Architectural Review Board Staff Report

Project Type: Site Development Section Plan

Meeting Date: May 10, 2012

Description: **Spirit Valley Business Park, Adjusted Lot 10:** A Site Development Section Plan, Landscape Plan, Lighting Plan, Architectural Elevations, and Architects Statement of Design for a 1.1 acre tract of land zoned "PI" Planned Industrial District located on the east side of Spirit Valley East Dr., south of Olive Street Rd.

SPIRIT VALLEY BUSINESS PARK ADJUSTED LOT 10 SITE DEVELOPMENT SECTION PLAN

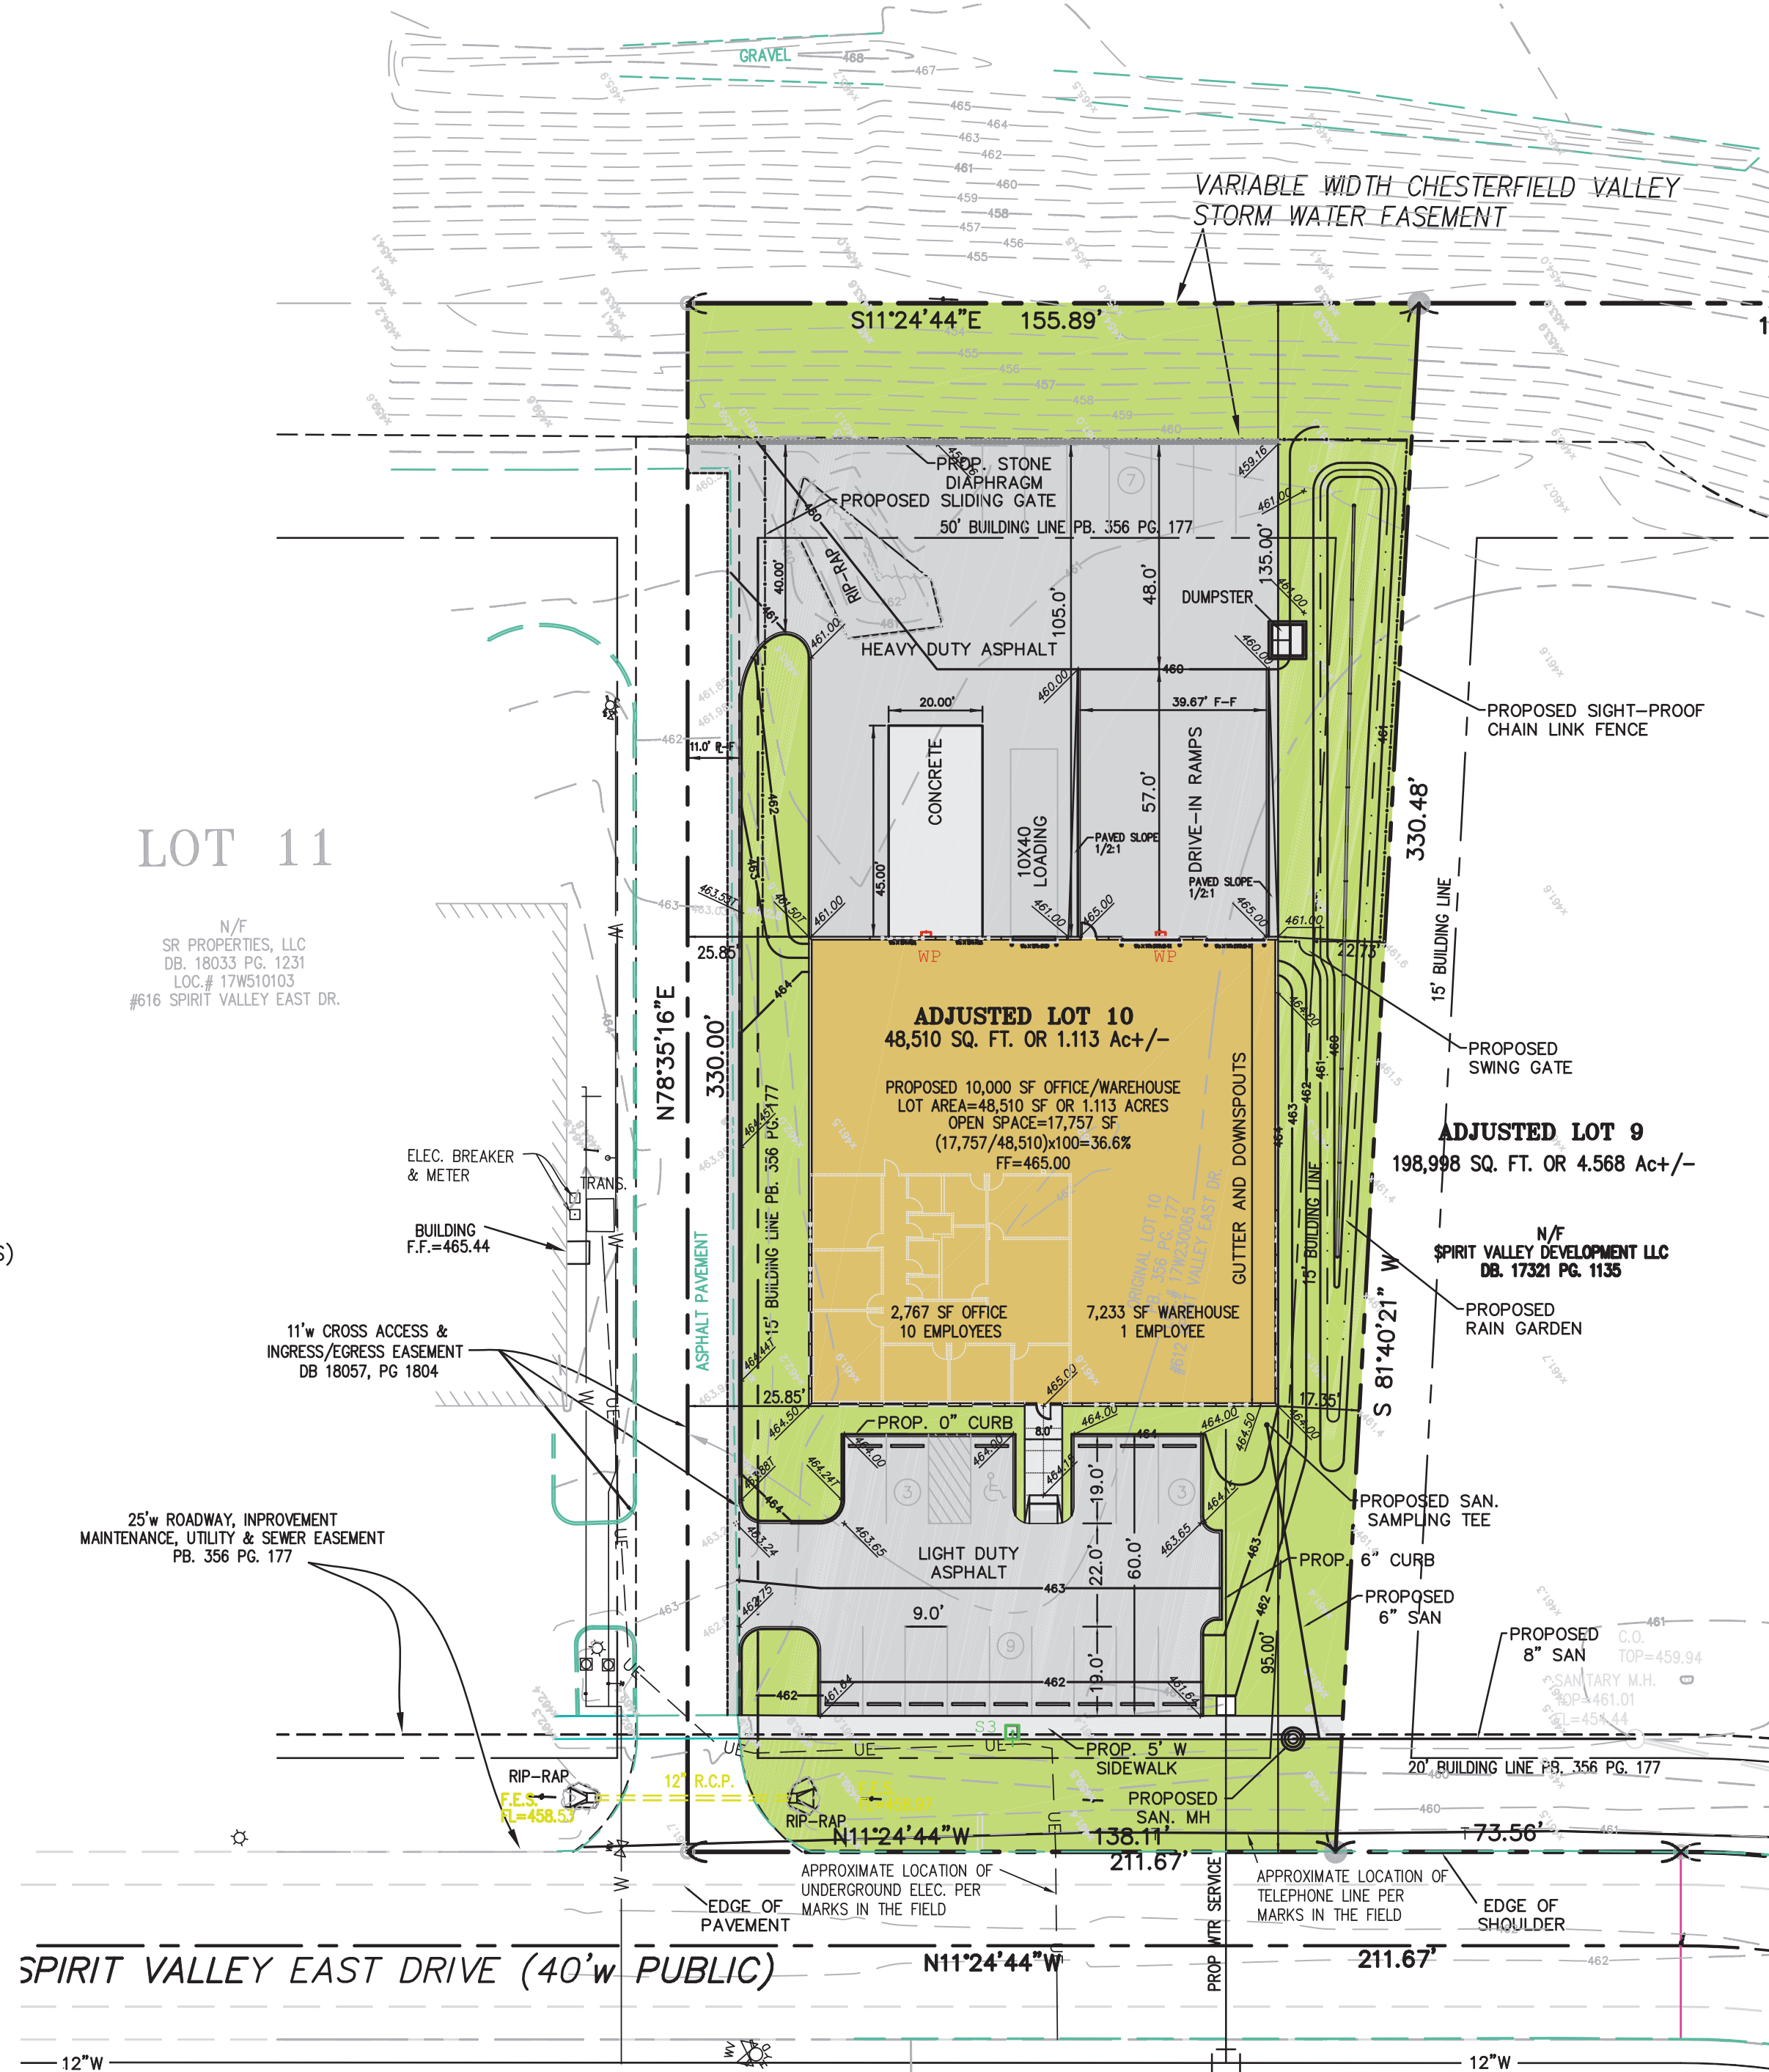
The site proposes one access point off Spirit Valley East Drive that will utilize an existing cross access easement with the property to the north. The plan also depicts a five foot sidewalk along the frontage of the site that will ultimately provide a continuous sidewalk throughout the development.

The proposed site plan does not include a separate trash enclosure. Staff has advised the applicant that a separate enclosure, matching the building is required for the site. The applicant has submitted the plans without the inclusion of a separate enclosure. For reference, all three of the previously developed lots in the Spirit Valley Business Park development include a separate enclosure with materials matching the building (i.e. not the chain-link with vinyl slats) even where a separate perimeter fence is provided.

SHEET NUMBER:	A1
ELEVATIONS	
PROJECT NUMBER: 12090	DATE: 04-19-12

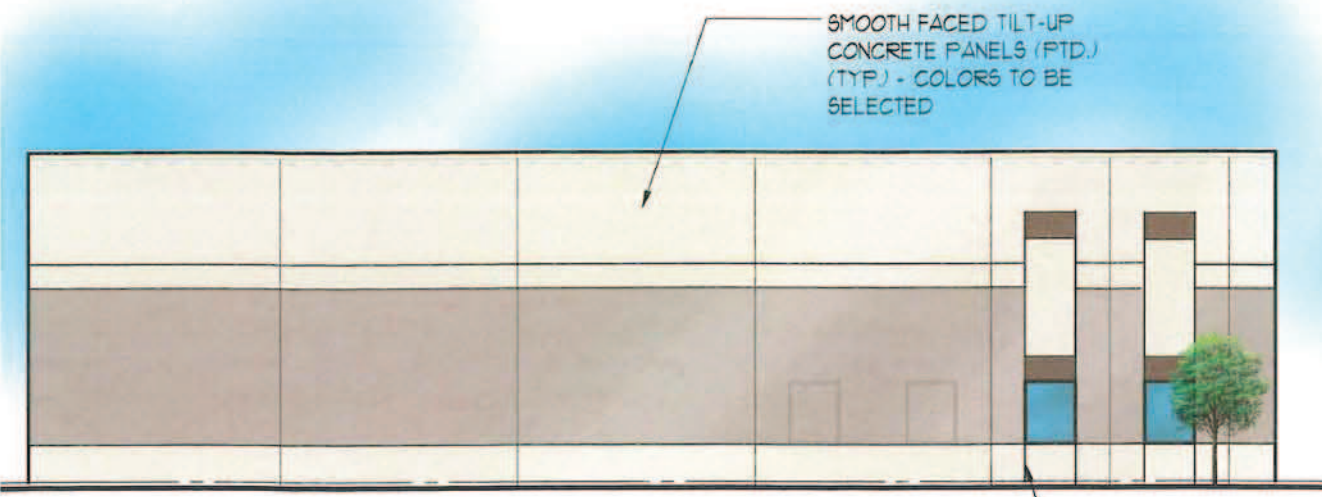
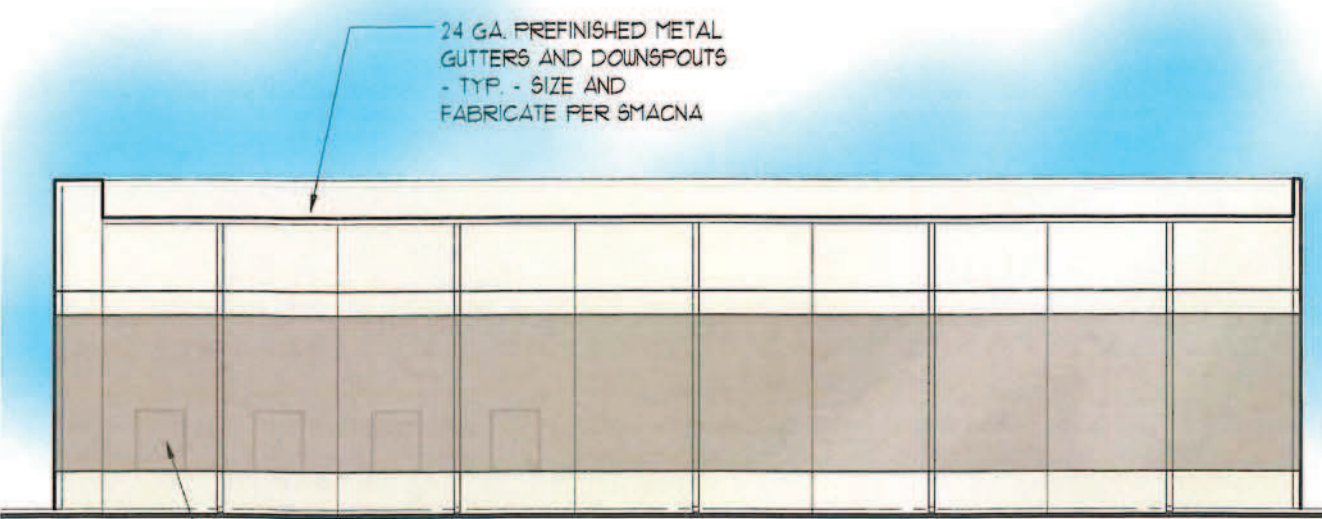
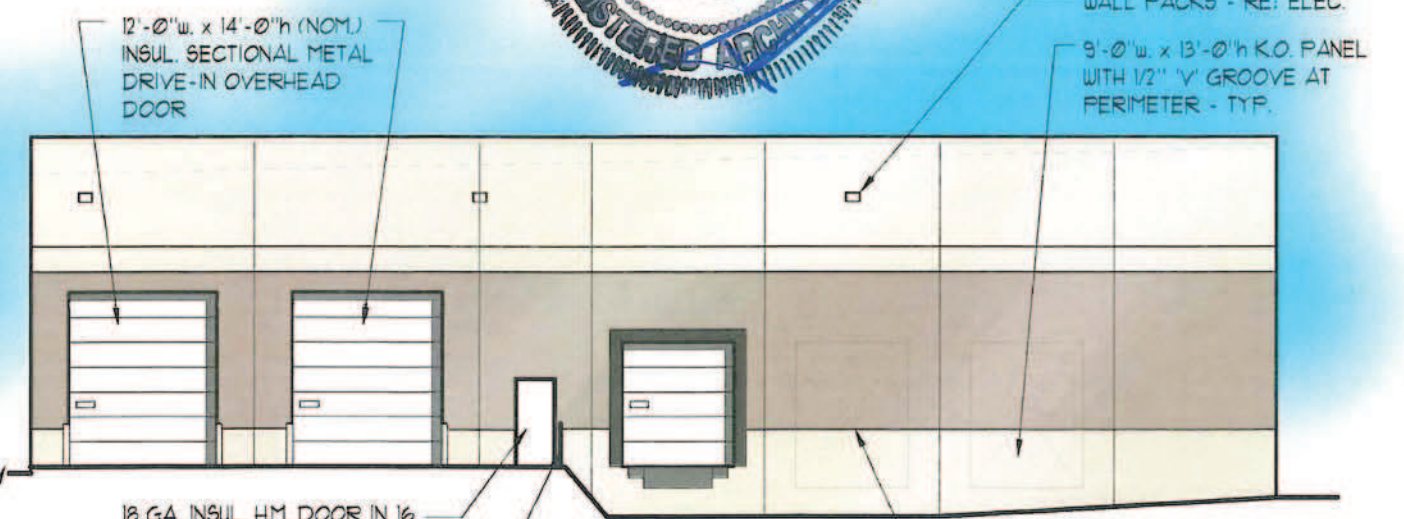
As mentioned previously, the building will be primarily comprised of tilt-up concrete panels. The front of the building is articulated with glass (gray tinted), reveals, and different paint colors (two earth tone colors).

Facades: The proposed building includes glass windows on the west (front) and northern (closest to Olive Street Rd.) elevations. The southern and eastern facades include knock out panels. The use of two colors is consistent on all four facades. As mentioned above under Landscape Design and Screening, a separate trash enclosure is not included at this time.
